36-50 E. Third Avenue Secretary of the Interior's Standards Analysis

City of San Mateo

Architectural Resources Group, Inc.
San Francisco, California

July 2020

Proposed south elevation (taken from Brereton Architects, “Draper University, 44 E 3rd Avenue, Planning Pre-application Revisions,” June 1, 2019). The western wall of the proposed addition should be shifted eastward so as not to partially obscure the building’s sixth bay.

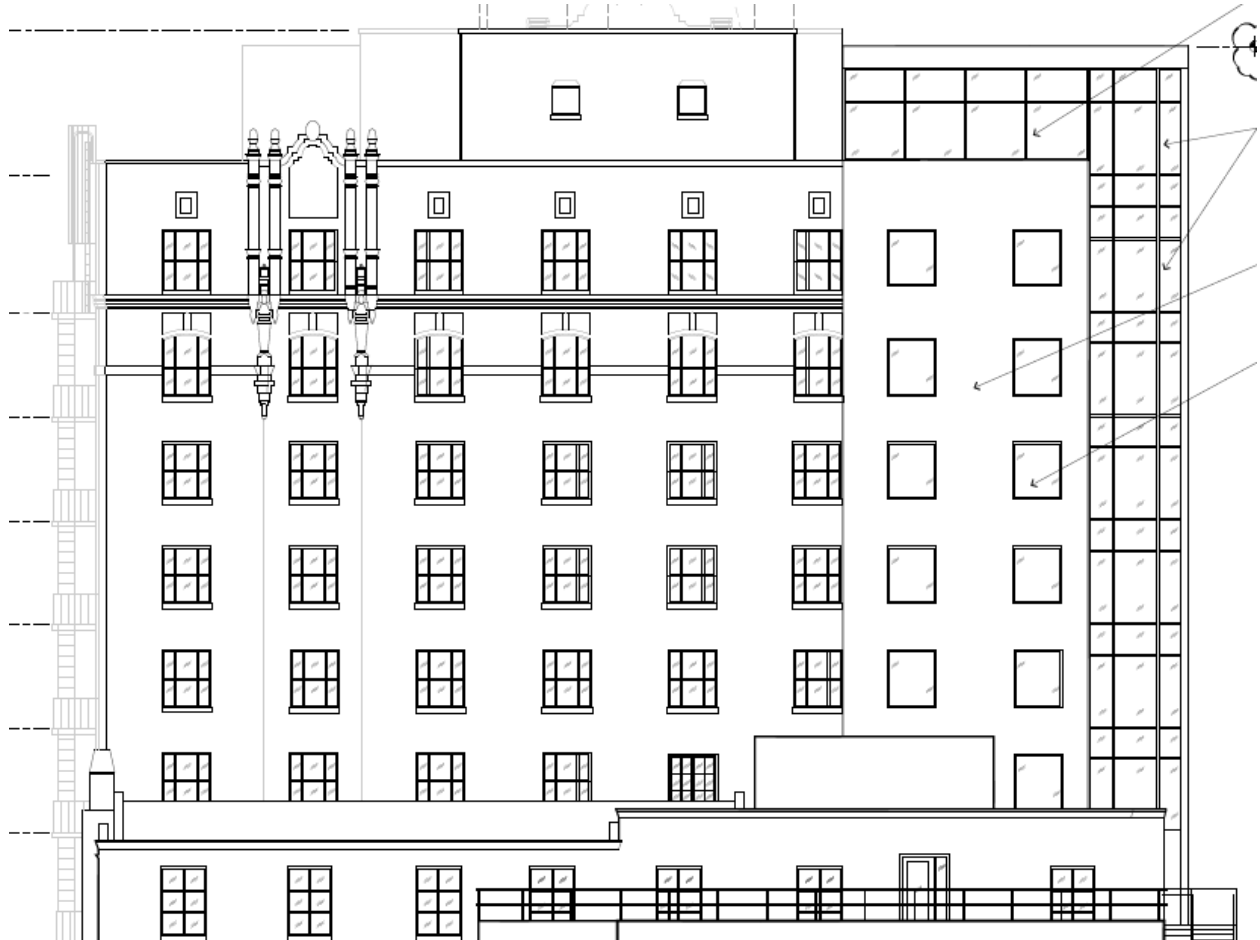
The stairwell and elevator addition’s location at the rear corner of the building reduces its prominence and helps to minimize its impact on the existing building. In addition, the south wall at the stairwell, which consists of punched windows the same size as this façade’s historic windows surrounded by unadorned stucco cladding, is compatible with the building’s Spanish Colonial Revival Style while, through its comparative simplicity, clearly being a contemporary addition.

- The architectural plans and renderings show the western wall of the addition meeting the existing building at the eastern edge of the windows in the sixth bay. The addition’s western wall should be shifted eastward so as not to infringe in the windows at the sixth bay. Ideally, this western wall would be shifted to align with the midpoint between the existing windows at the sixth and seventh bays, so as not to obscure any portion of the sixth bay.

- The two bays of punched windows at the stairwell should be shifted to be aligned with the original window openings they are obscuring. In particular, based on the project drawings, it appears that the left bay of new windows should be shifted rightward, and the right bay of windows should be shifted leftward. This change will reduce the extent to which the addition modifies the symmetric character of the rear façade.

- The full height glazing at the elevator shaft and penthouse level of the stairwell is starkly at odds with the building's Spanish Colonial Revival Style. Instead, we recommend that the design approach at the stairwell (stucco cladding with punched windows) be extended to the entire addition. This will enable the addition to be compatible with the historic building, while at the same time, through slightly simpler window, wall and roofline treatments, be differentiated from it.

- The compatibility of the addition could be further reinforced through:
 - addition of a string course between the seventh and eighth stories that is similar to but simpler than that on the existing building; and

- Arched window openings at the south wall of the seventh story that match the existing window openings at that location.
